**RM03**

DISK DRIVE

PROCESSOR TYPE 10, 11, VAX

Engineering Change  
Order Log

FIGURE 2

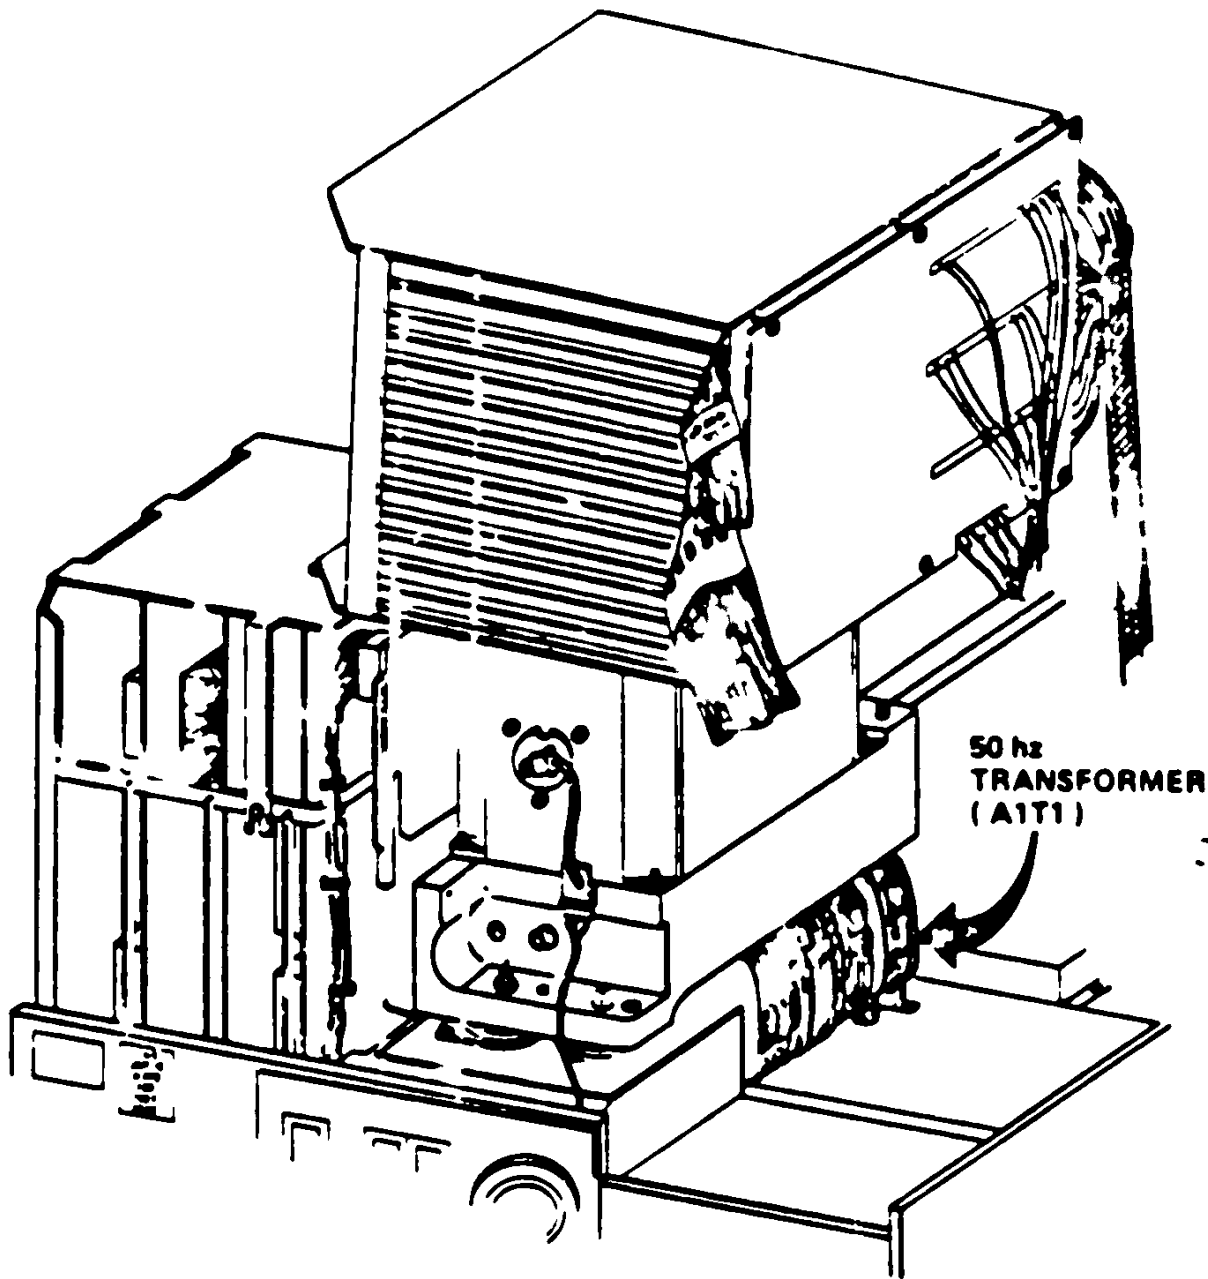
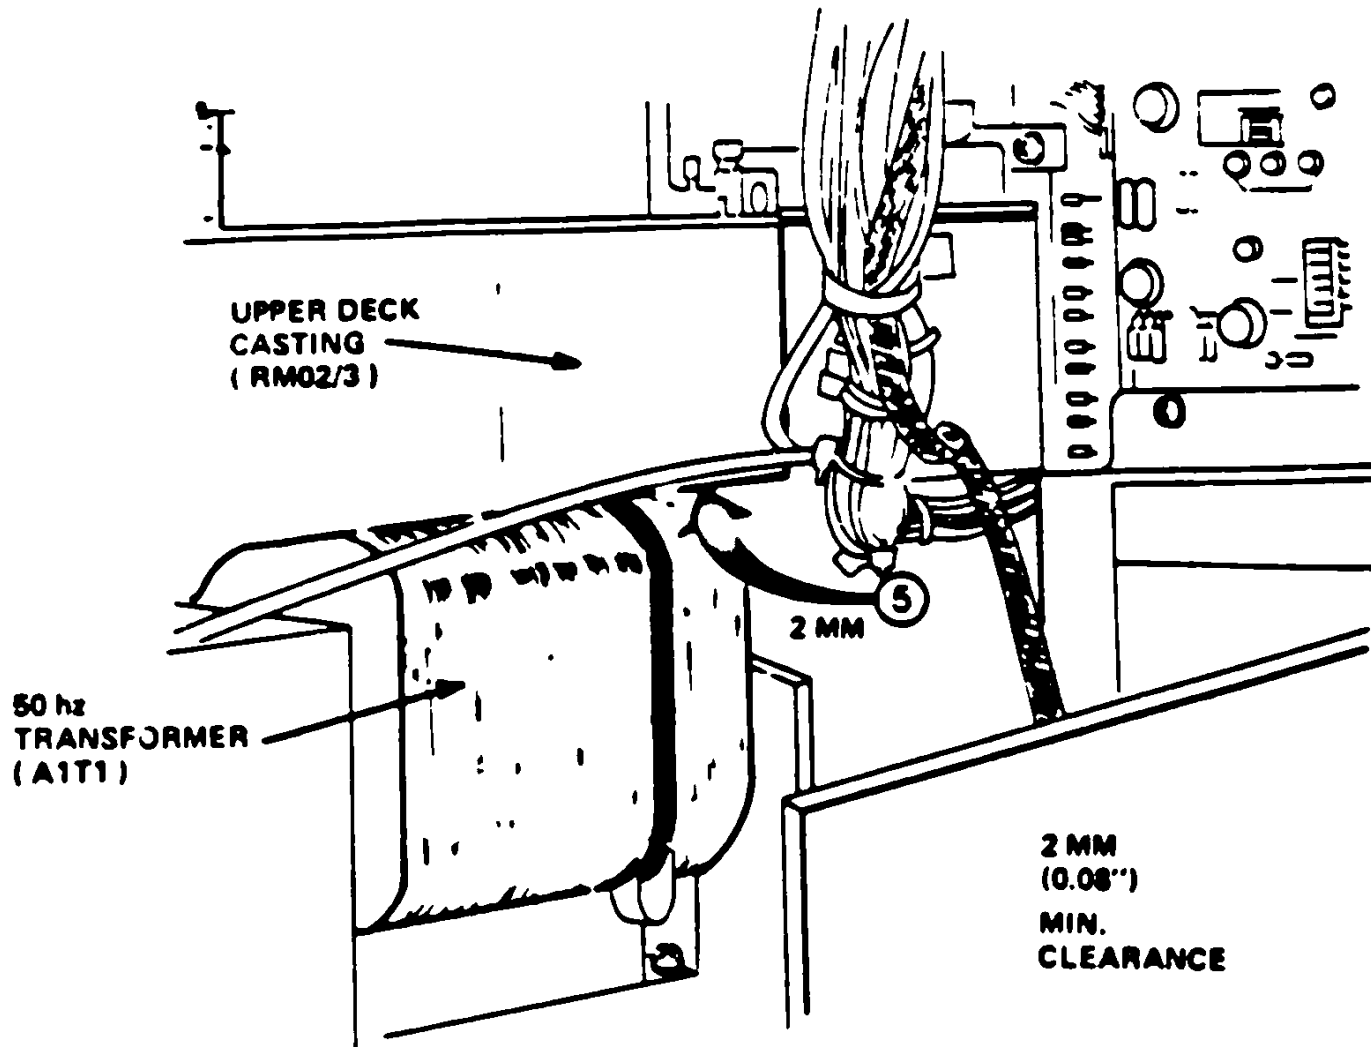
**RM03-M0034 CODE: F**  
AUG 85 - IN-PLANT EFFECTIVITY MAY 85  
PROBLEM: Transformer (A1T1) may come in contact with the upper deck plate assembly (when raised or lowered); resulting in damage to the transformer winding insulation and/or shorting of the transformer windings to the chassis.  
FIELD EFFECTIVITY: Inspect and retrofit (if necessary) all RM03 50 Hertz Drives. All 29-22908 50 Hertz Replacement Transformers require incorporation of this FCO when they are installed.  
QUICK CHECK. Drive Revision is "T" or standoffs or Power Amplifier Assembly.

9. With the deck in its lowered position, check to be sure that there is a minimum clearance of 2mm (.08 inches), between both the left and right side of the AC power transformer winding insulation and any part of the upper deck plate assembly. The critical areas of clearance are noted by the arrows labeled with no. 5 in FIGURE 3. A flashlight and feeler gauge may be required. The side of the transformer closest to the power supply assembly, see FIGURE 4, can be observed by looking through the hole in the rear of the positioner (ARROW 3, FIGURE 1) and applying sufficient light (with a flashlight) as shown by ARROW 4 in FIGURE 1. Assure that there are no pinched wire harnesses and no chance of damage due to contact between the transformer assembly and the upper deck chassis or other surrounding components.

FIGURE 5

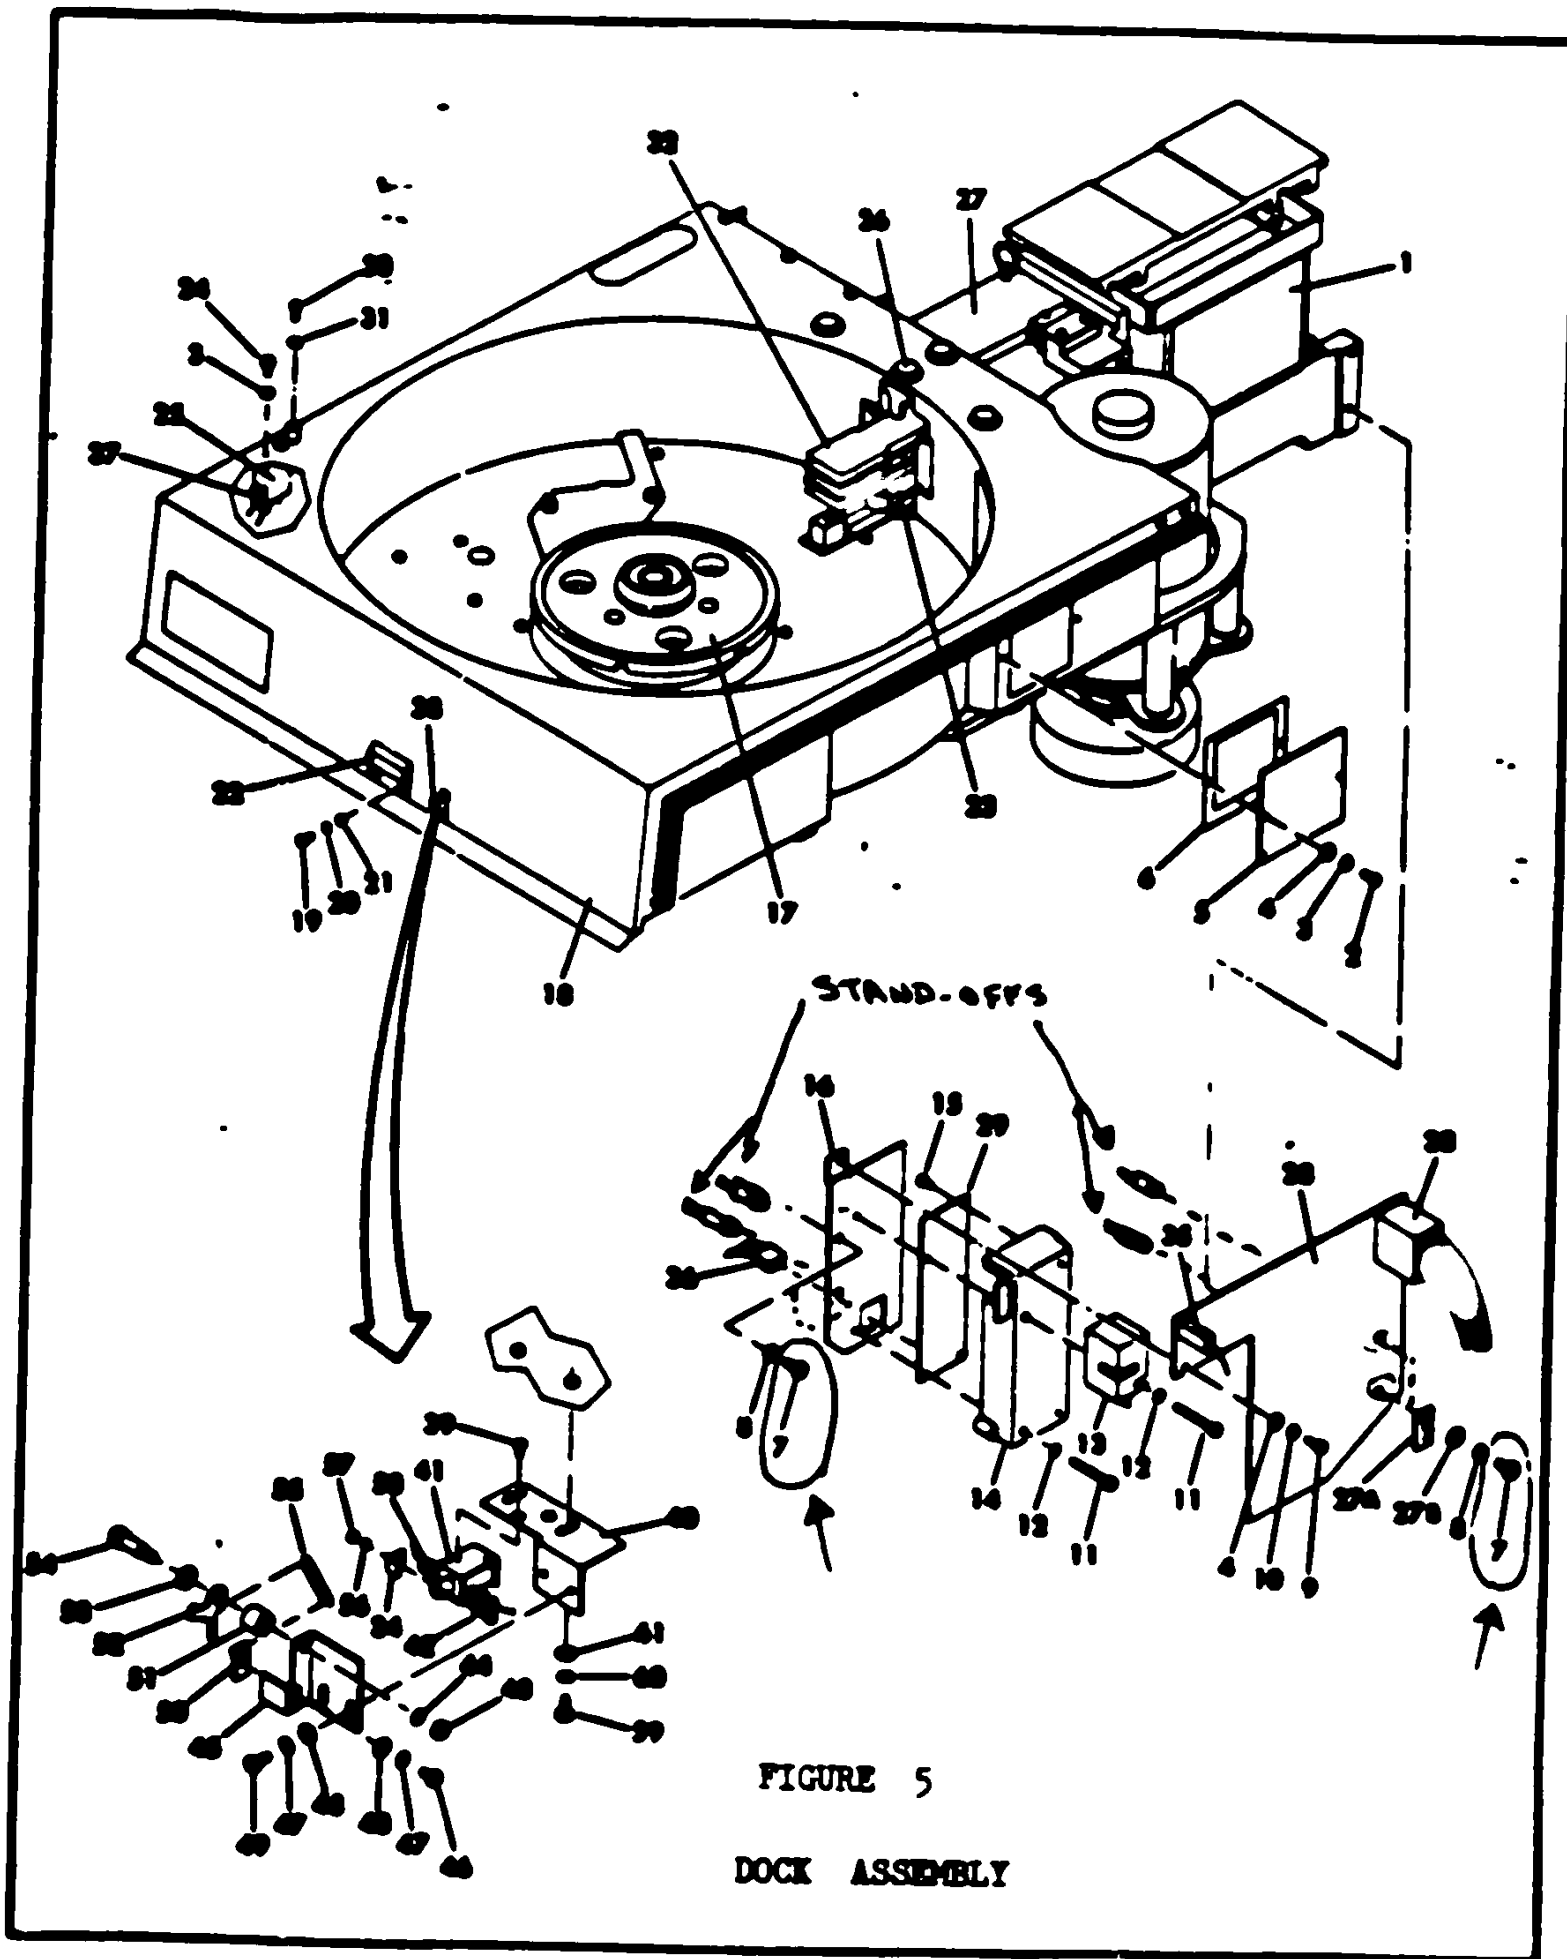
- A. Remove the quick connect terminal (yellow leadwire) from Faston on the upper left hand corner of the power amp assembly A3A04 (ITEM 35 on FIGURE 5).

25. Remove the two most left-hand screws (10-32 x 3/8 Item 7 FIGURE 5) that secure the servo preamp housing to the baseplate and discard them. Carefully lift the servo preamp housing up approximately 2 inches. Disconnect connector J-8 (Item 36 FIGURE 5) from the bottom of the servo preamp housing.

26. Lift servo preamp housing out of the drive.
27. Install the four new standoffs supplied in the FCO kit to the baseplate in mounting holes for the servo preamp housing and the mounting holes for the power amp assembly, as shown in FIGURE 5.

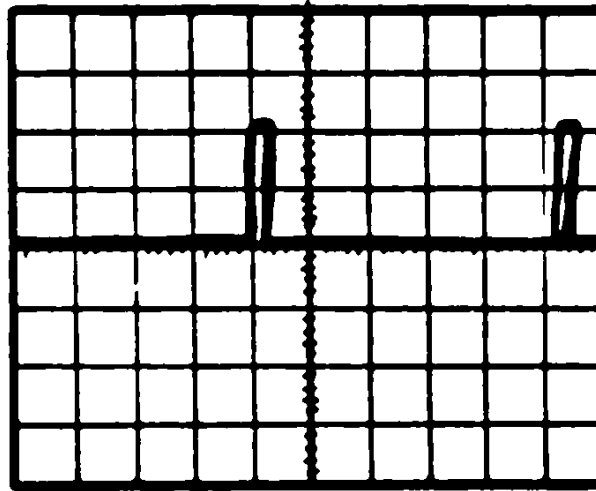
THE PICTURE SHOWN IN CHAPTER 4 OF THE RM02/03 DISK SUBSYSTEM SERVICE MANUAL (EK-RM023-SV-001) FOR THE VELOCITY GAIN ADJUSTMENT IS CORRECT. THE PROCEDURE IS CORRECT; HOWEVER, THE OSCILLOSCOPE DISPLAY COULD LOOK LIKE THE ONE BELOW IF YOU LOOKED AT TEST POINT B02-3A INSTEAD OF B09-3A.

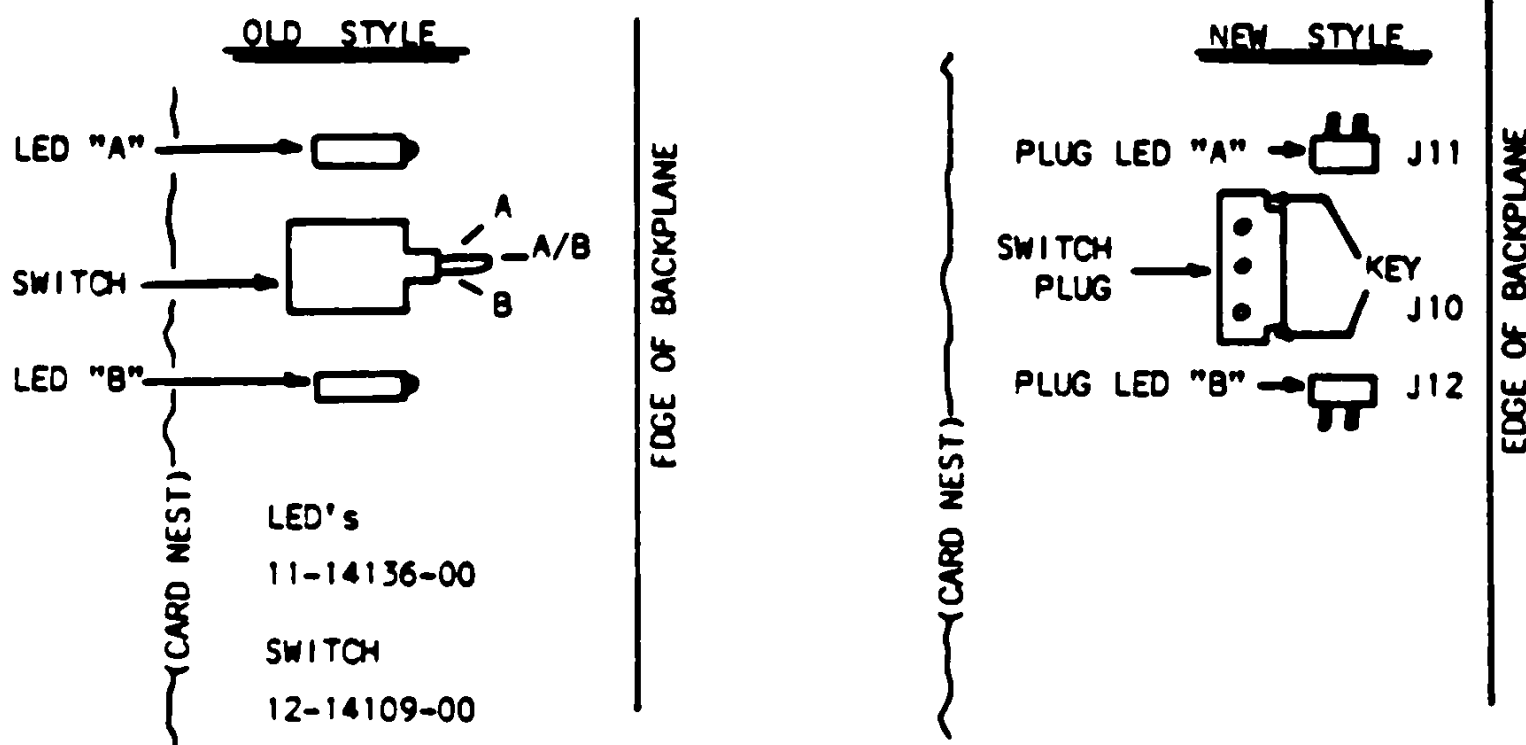
Ensure that the center plug has the keyed side towards the edge of the backplane, away from the card nest as shown below.

If the keyed part of the switch plug is facing the wrong way (towards the card nest) unsolder the plug and reorientate it correctly.

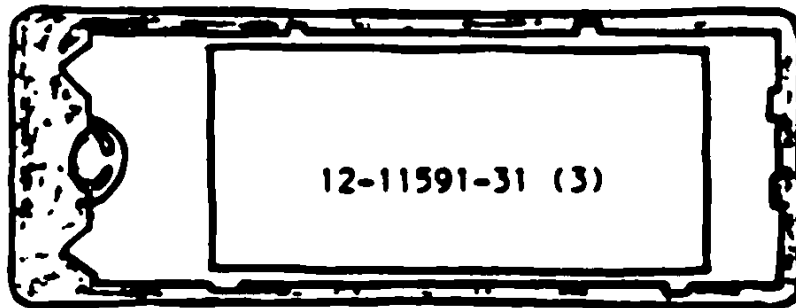
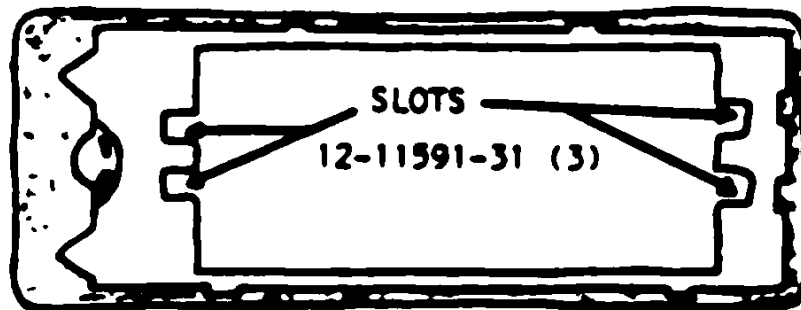
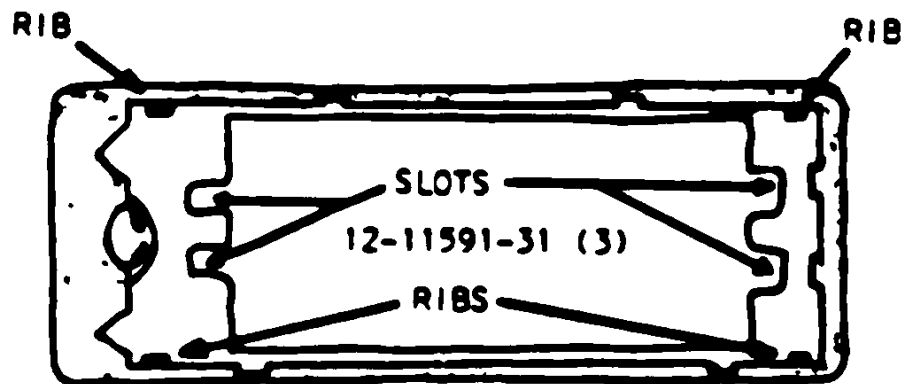
Some incorrect "Amp" connectors may have made it to the field on the ends of MASSBUS cables. If you have the incorrect ZIF connectors the MASSBUS cable end may fall off the connector bulkhead during normal operation. The cables were built between October 1980 and February 1981. Below are the three (3) styles of connectors as viewed from the pin end of the plug. If you are having this problem please check your ZIF connectors.
